Silver Oak Subdivision

ENGINEER'S SEAL	SILVEROAK ESTATES GRADING AND DRAINAGE PLAN	DRAWN BY WCUJ
DAVID SOULE P.E. #14522	Rio Grande Engineering 1606 CENTRAL AVENUE SUITE 201 ALBUQUERQUE, NM 87108 (505) 872-0999	3-30-16 12-18-15 21525-LAYOUT-9-28-15
		SHEET # 3
		JOB # 21525

ENGINEER'S SEAL		SILVEROAK ESTATES GRADING AND DRAINAGE PLAN	DRAWN BY WCWJ
			3-30-16 12-18-15
			21525-LAYOUT-9-28-15
3-30-16		<i>Rio Grande Engineering</i> 1606 CENTRAL AVENUE SUITE 201 ALBUQUERQUE, NM 87105 (505) 872-0959	SHEET # 3
DAVID SOULE P.E. #14522			JOB # 21525

GRADING AND DRAINAGE PLAN

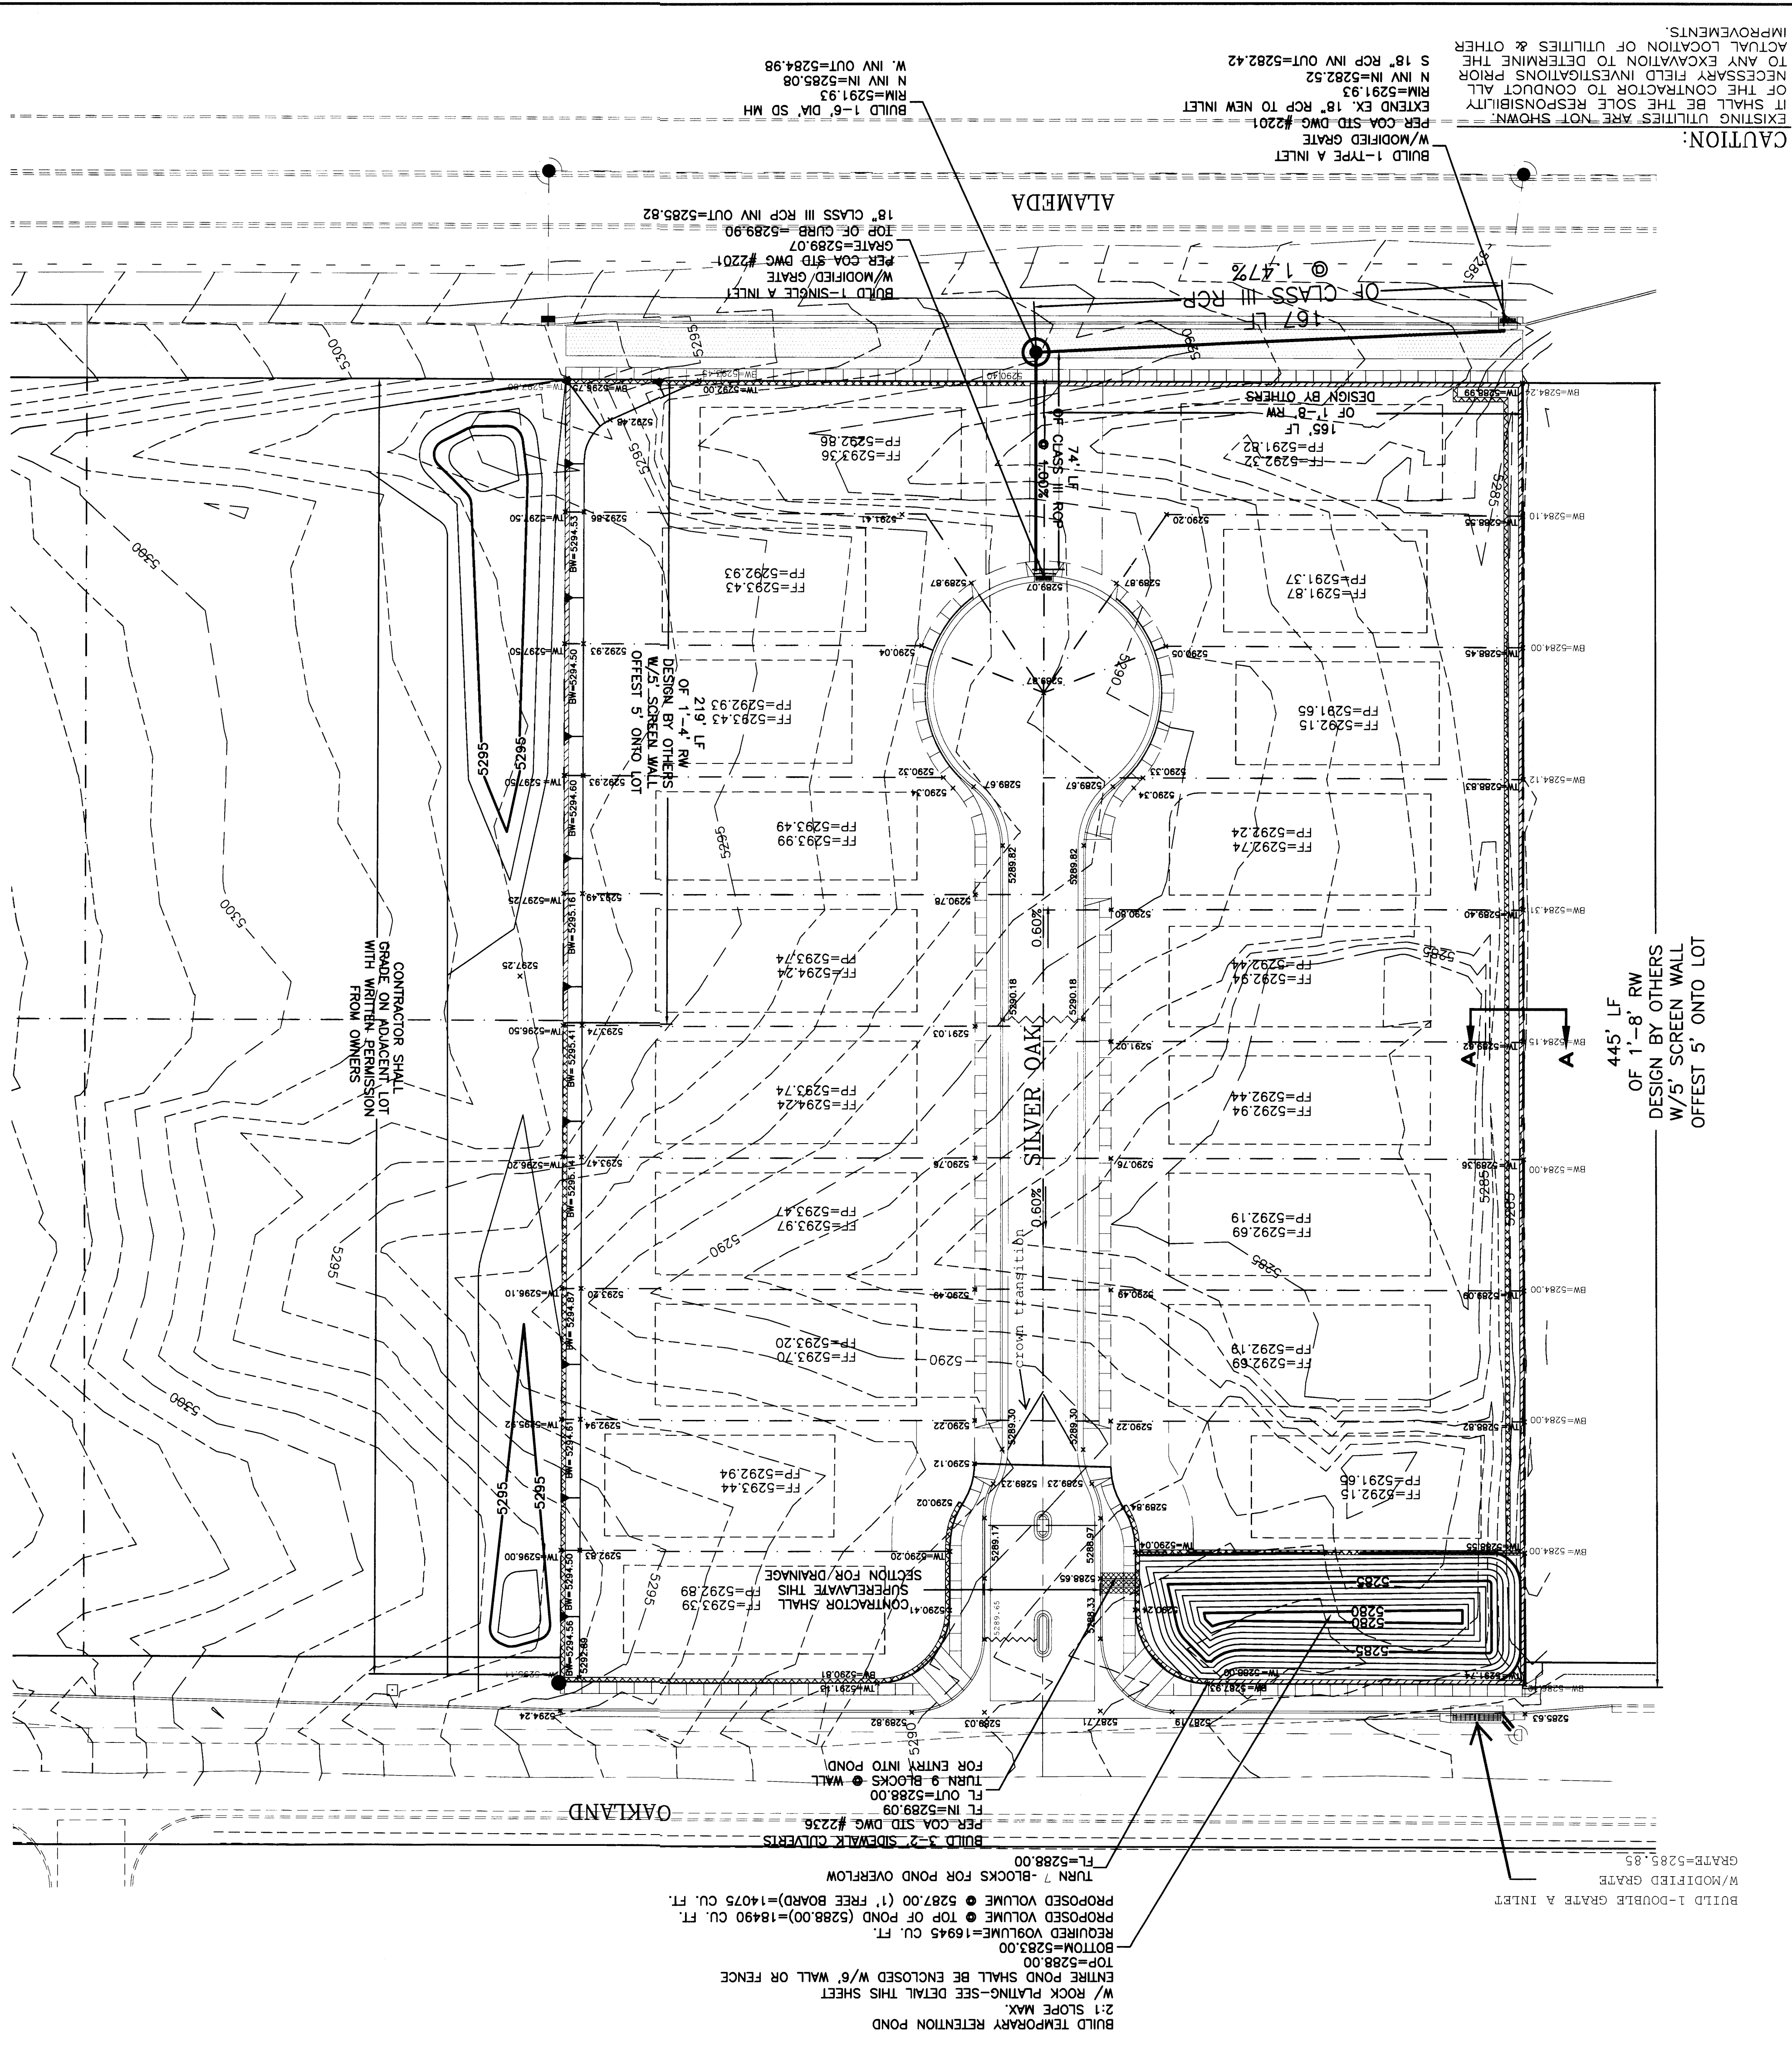
T. - Clarify that crown needs to be warped to drain, depressed gut w/ pan

Show ^{overflow} as described in report.

Build notes 5289.84
for wall opening
on DRC set
